Dominion Nuclear Connecticut, Inc.  
Millstone Power Station  
Rope Ferry Road  
Waterford, CT 06385

Docket No. 50-423  
B18314

Millstone Nuclear Power Station, Unit No. 3  
Technical Specifications Change Request 3-11-00  
Reactor Coolant System Heatup and Cooldown Curves

FIGURE 3.4-2

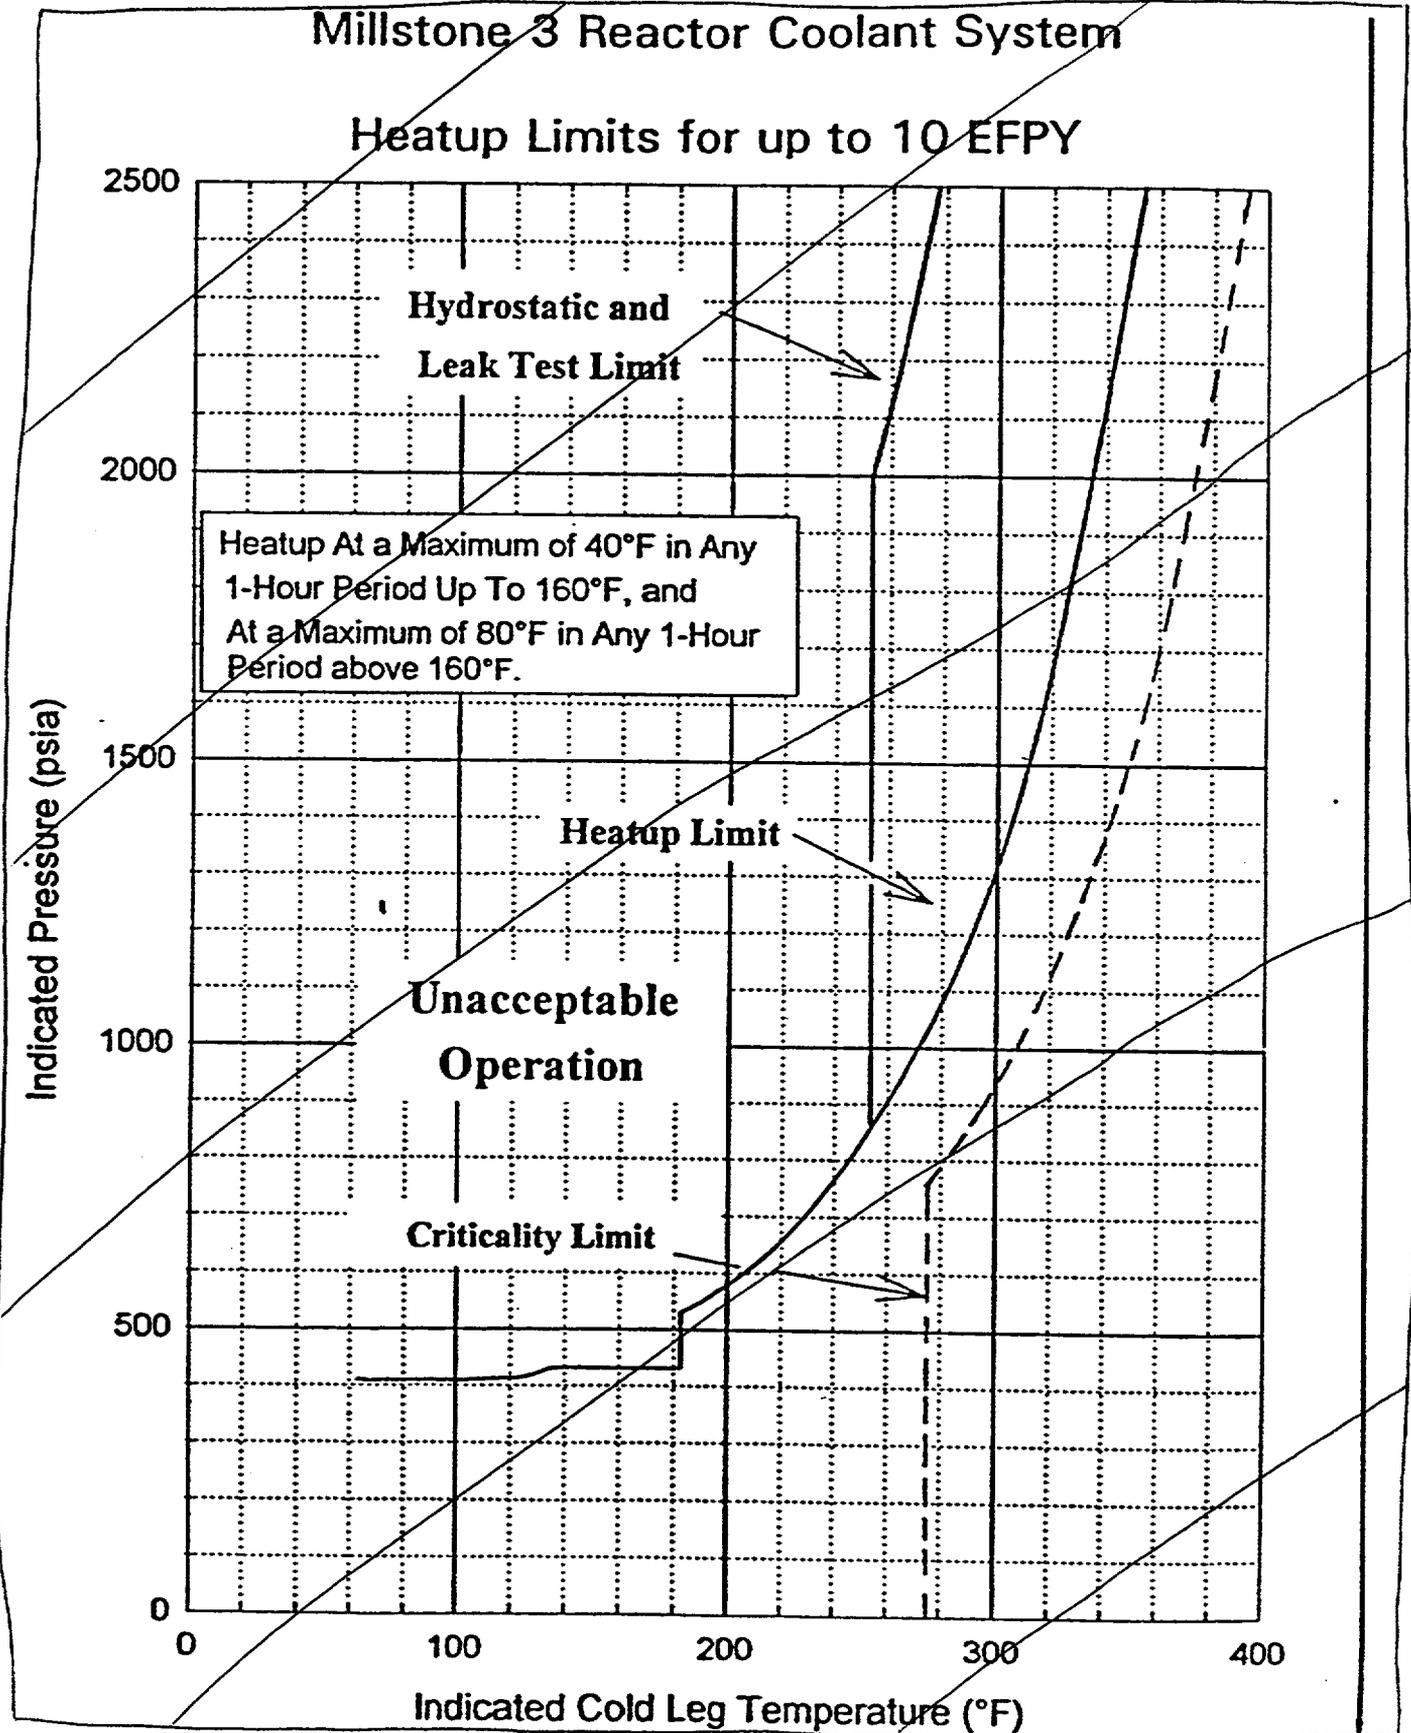
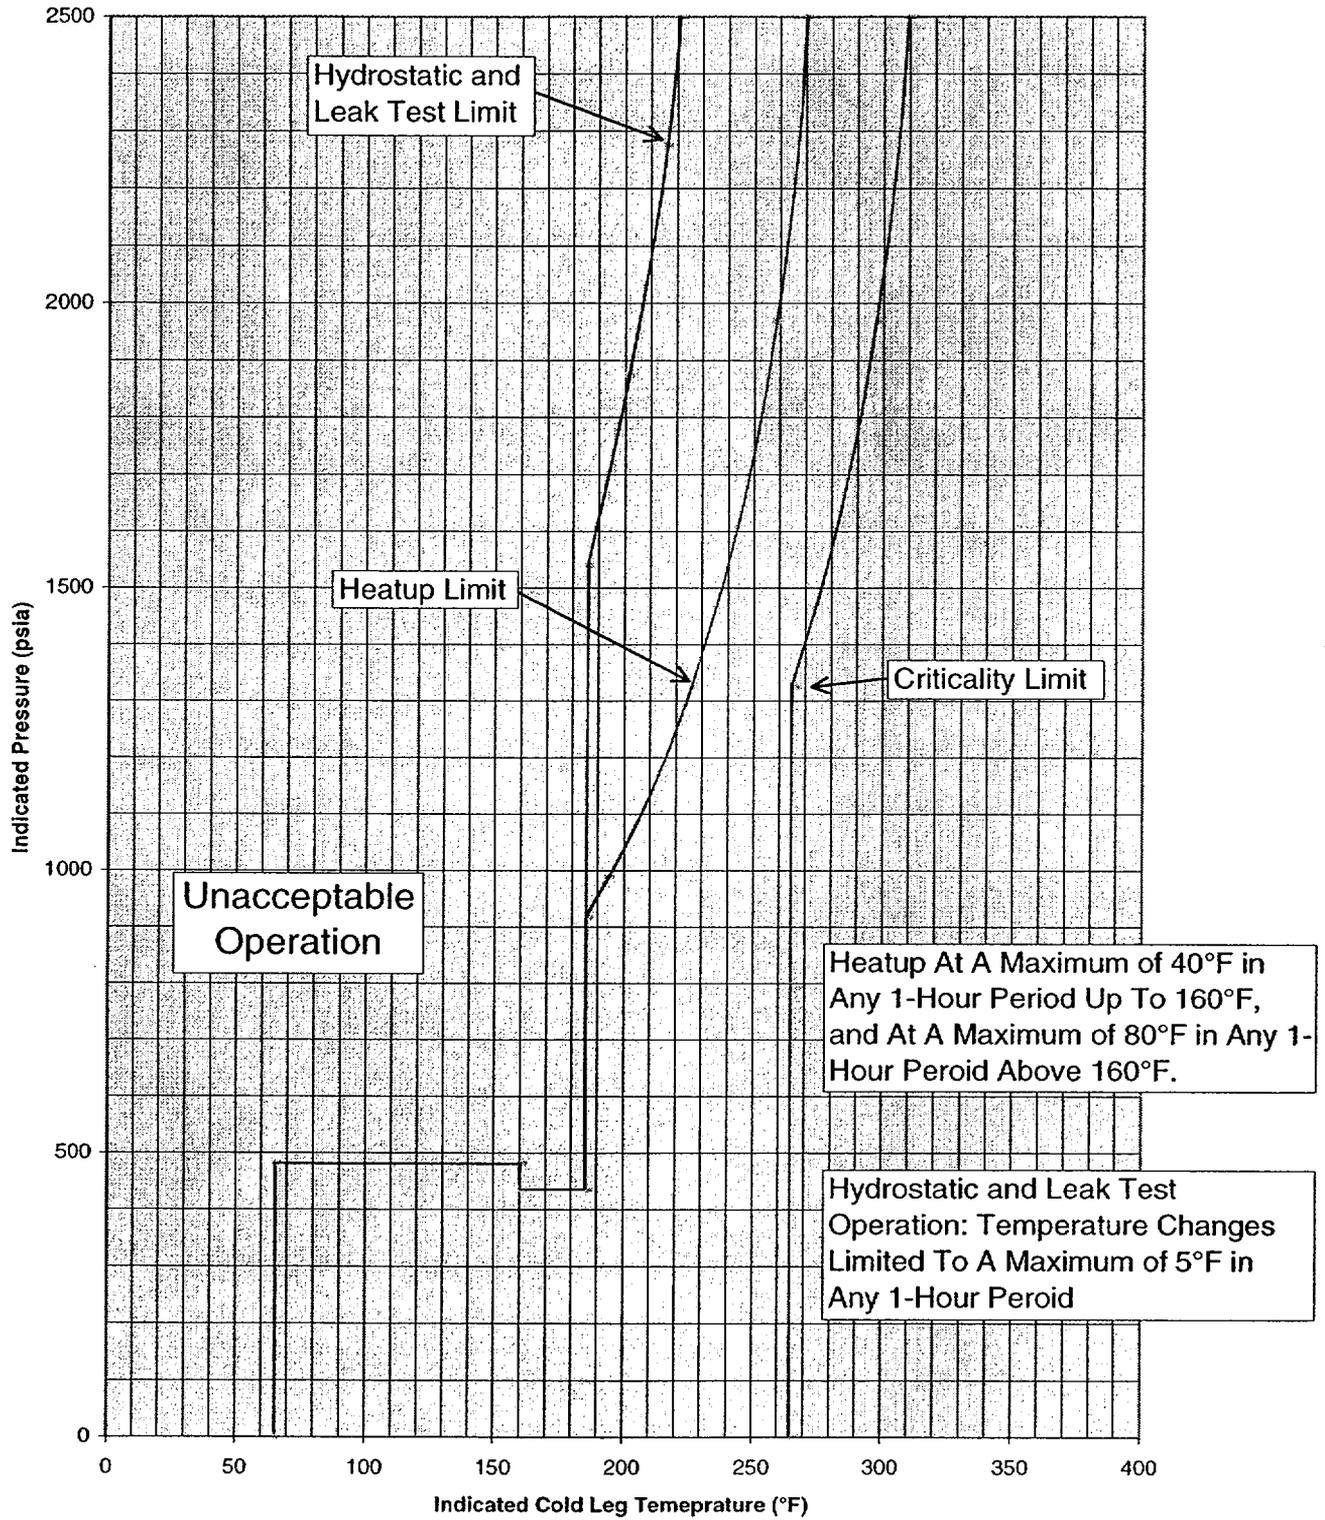
3. Figure 3.4-2 will be replaced by a new curve, based on the revised analysis, that is applicable to 32 EFPYs. The hydrostatic and leak test limit will be added to Figure 3.4-2.

Figures 3.4-2 and 3.4-3 have been replaced by new curves, based on the revised analysis. The new curves are applicable to 32 EFPYs. The hydrostatic and leak test limit has been added to Figure 3.4-2.

**Millstone 3 Reactor Coolant System  
Heatup Limitations for Fluence up to 1.97E+19 n/cm (32 EFY)**

Figure 3.4-3

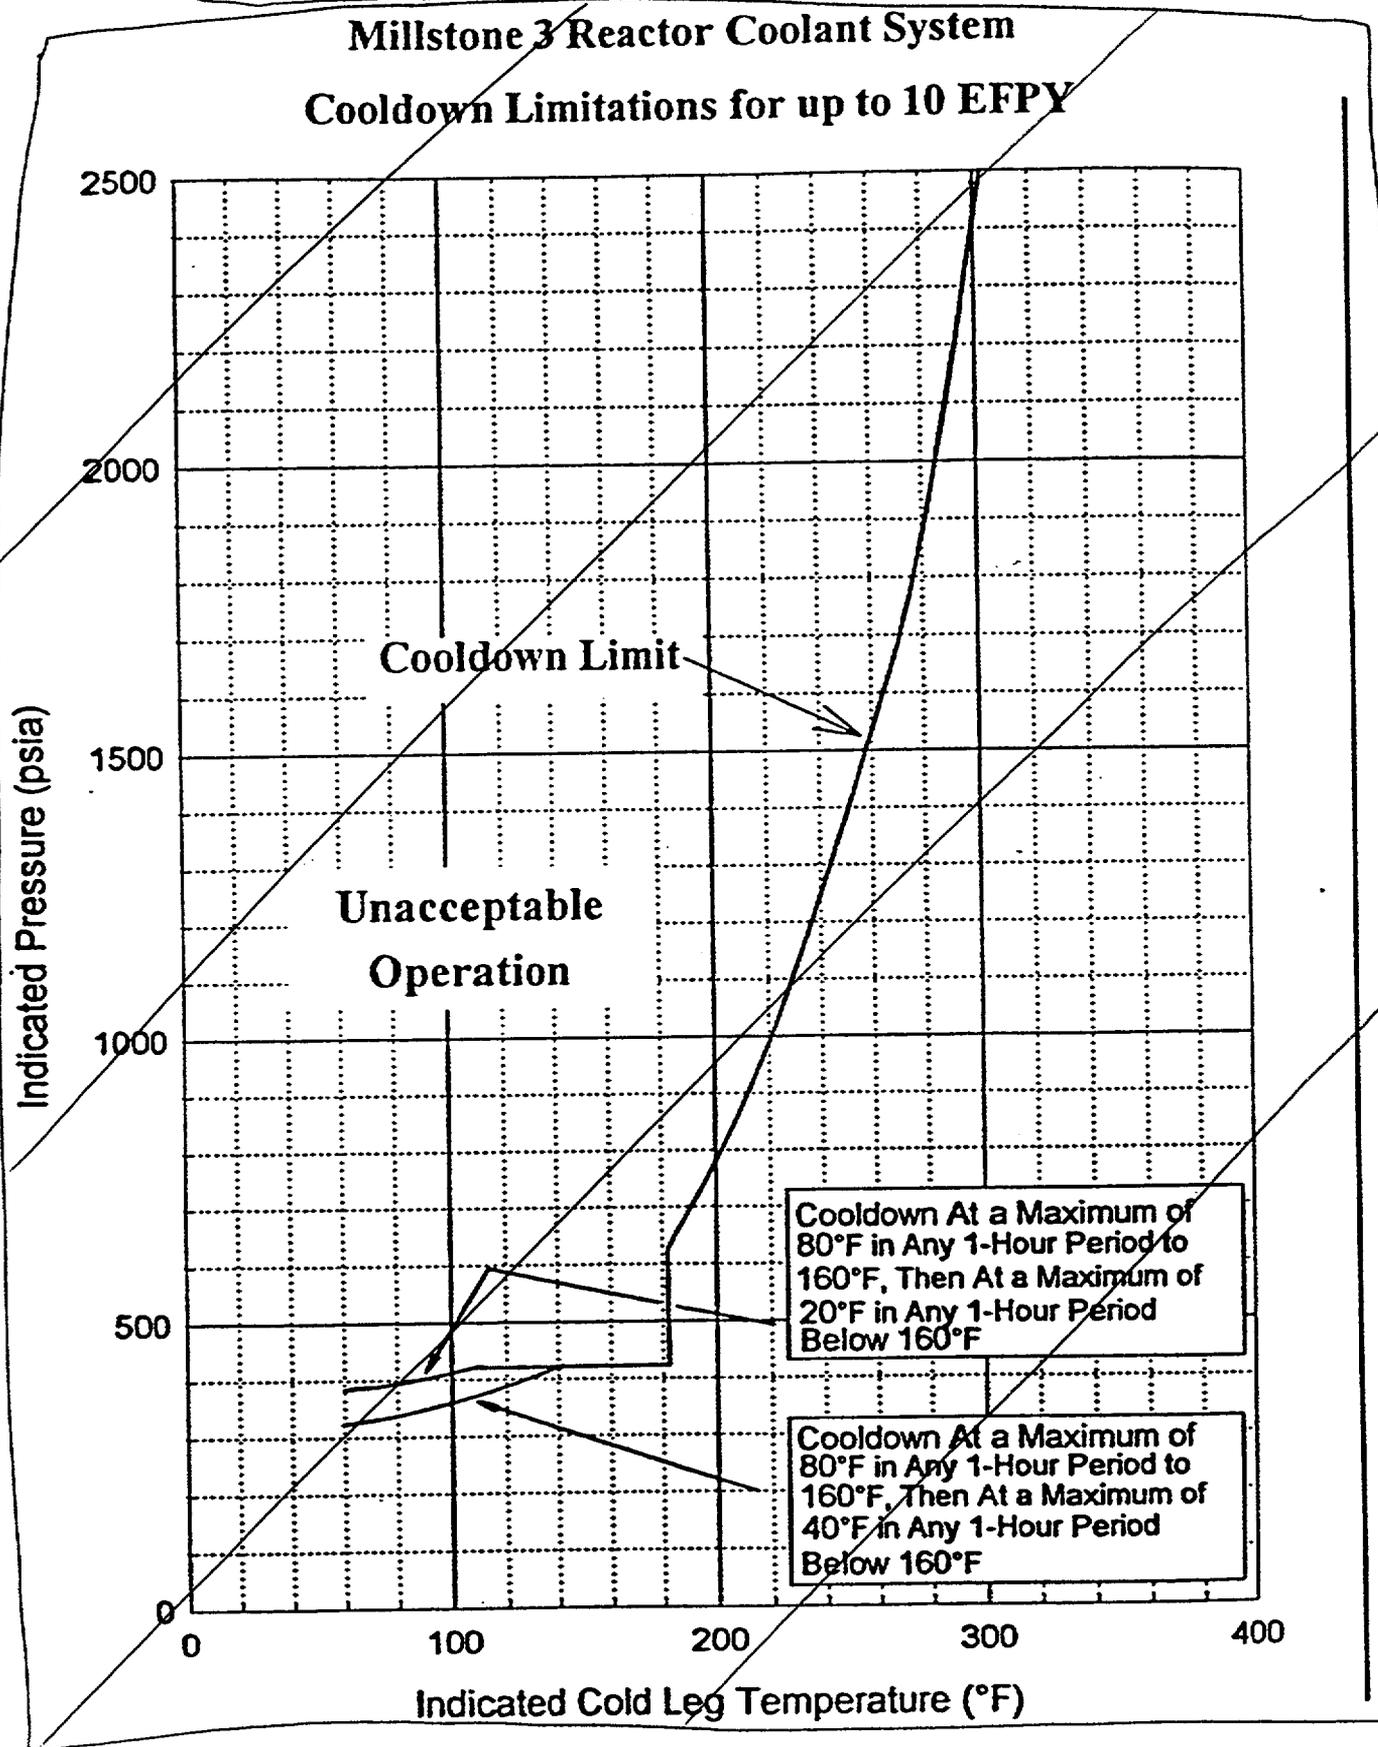
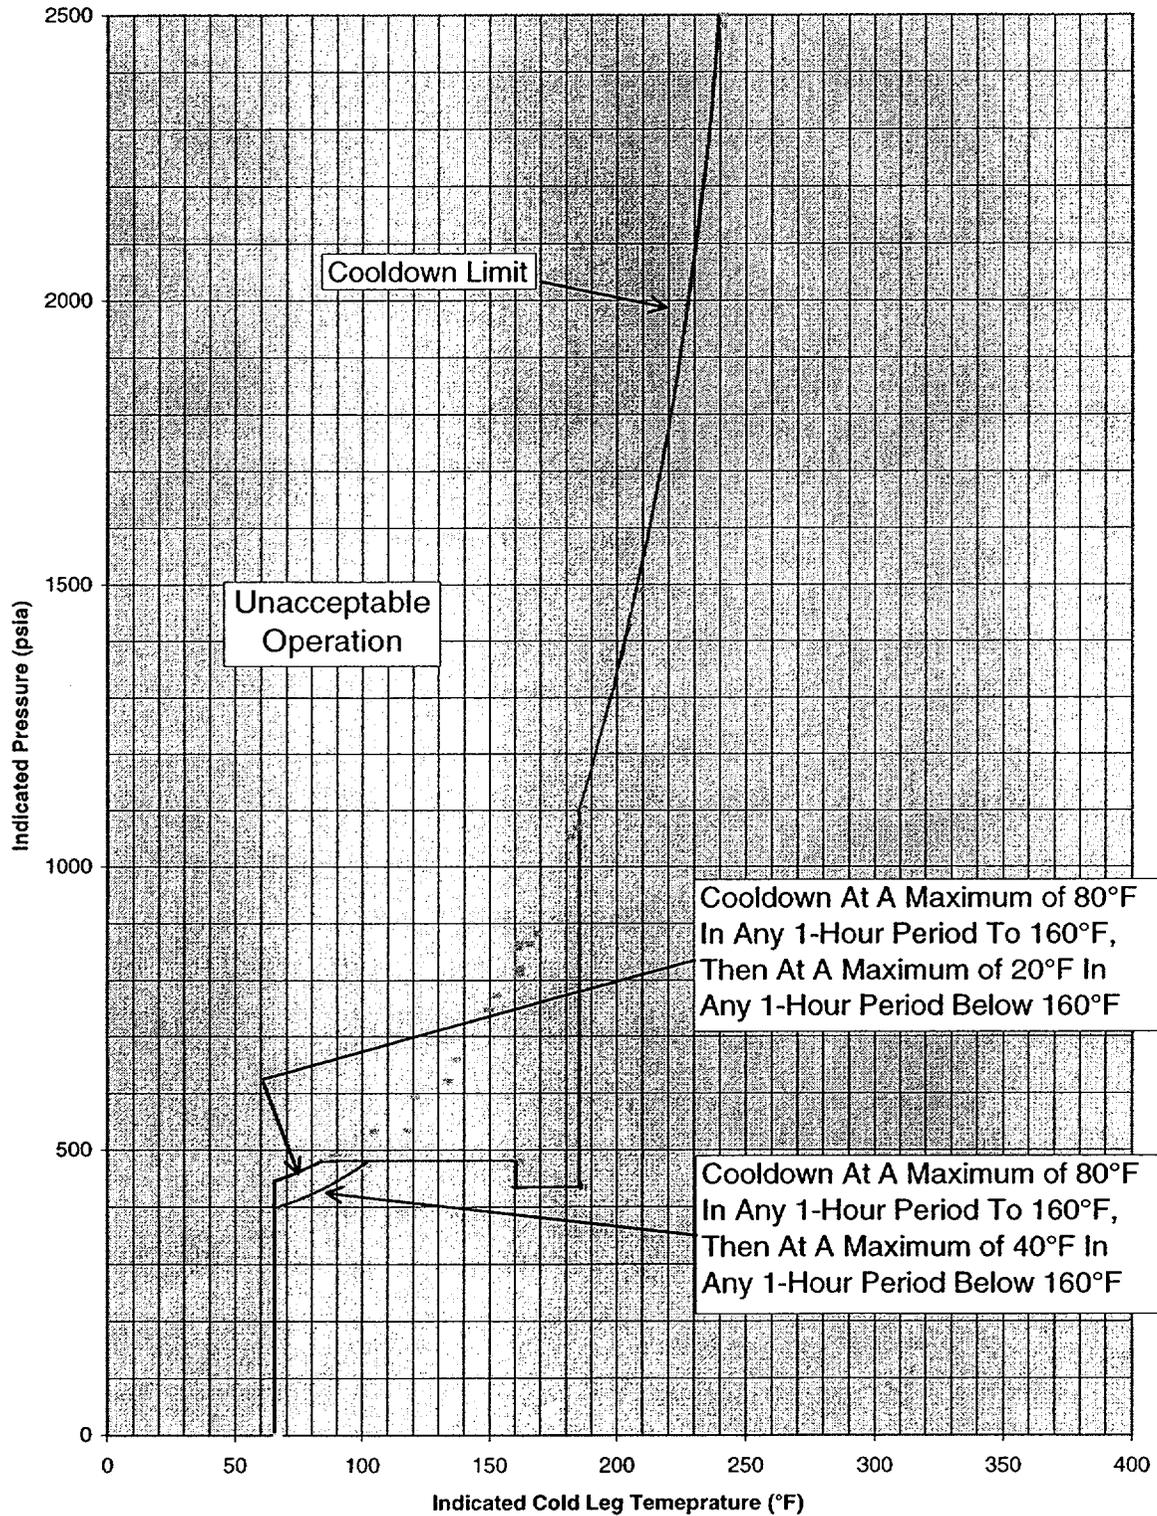
4. Figure 3.4-3 will be replaced by a new curve, based on the revised analysis, that is applicable to 32 EFPYs.
5. Table 4.4-5 will be revised. The capsule numbers and vessel locations have not been changed. The lead factors have been revised based on the evaluation of capsule X. The withdrawal column has been renamed and updated to reflect actual capsule withdrawal. A column containing fluence values has been added. The current footnote has been revised, and numerous footnotes added consistent with the proposed table changes.

**Millstone 3 Reactor Coolant System  
Cooldown Limitations for Fluence up to 1.97E+19 n/cm (32 EFPY)**
